Access Compliance Report

Public Rights-of-Way

(Curb Ramps)

Intersection ID: 10023924	Main Street: CONLAN_CR	Cross Street: N/A	Location:	N
ADA ID: 1DC7100BD265	Ramp Type: Perp	Initial Pass/Fail: Fail	Overall Compliance: No	Severity Score: 25

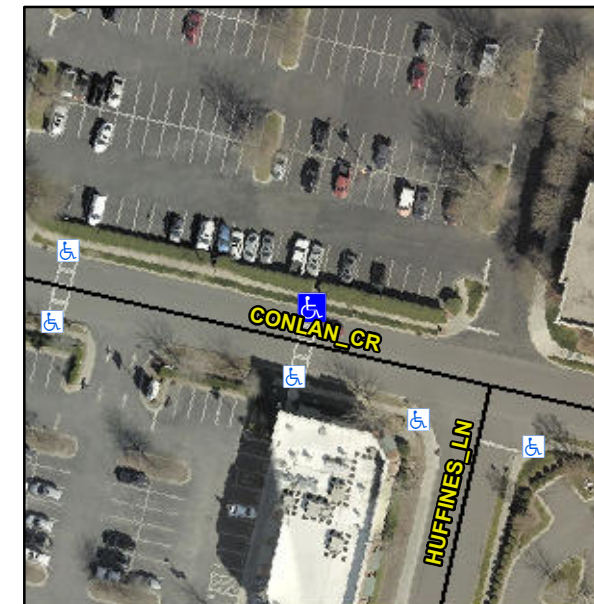
Not Found, R304.2.2

Compliance	Description	Data	Compliance	Description	Data
N/A	Ramp Length (in)	48.0	No	Ramp Slope (%)	13.4
Yes	Ramp Width (in)	61.0	Yes	Ramp XSlope (%)	1.3
N/A	Flare Type LT	N/A	N/A	Flare Type RT	N/A
N/A	Flare Slope LT (%)	N/A	N/A	Flare Slope RT (%)	N/A
N/A	Flare Traversable LT?	N/A	N/A	Flare Traversable RT?	N/A
N/A	Landing Length (in)	N/A	N/A	DWS Provided?	N/A
N/A	Landing Width (in)	N/A	N/A	DWS Contrast?	N/A
N/A	Landing Slope (%)	N/A	N/A	DWS Length (in)	N/A
N/A	Landing X Slope (%)	N/A	N/A	DWS Full Width?	N/A
N/A	Landing Curb? (Y/N)	N/A	N/A	DWS Offset (in)	N/A
N/A	Shared Landing?	N/A			
N/A	Gutter Ponding?	N/A	N/A	Gutter Slope (%)	N/A
N/A	Gutter Lip Ht (in)	N/A	N/A	Gutter X Slope (%)	N/A
N/A	Painted X Walk1?	Yes	N/A	Painted X Walk2?	N/A
	X Walk 1 Direction	To SW		X Walk 2 Direction	N/A
N/A	X Walk 1 Width (in)	102.5	N/A	X Walk 2 Width (in)	N/A
	X Walk 1 Slope (%)	3.3		X Walk 2 Slope (%)	N/A
	X Walk 1 X Slope (%)	3.1		X Walk 2 X Slope (%)	N/A

Remove & Replace Entire Ramp.
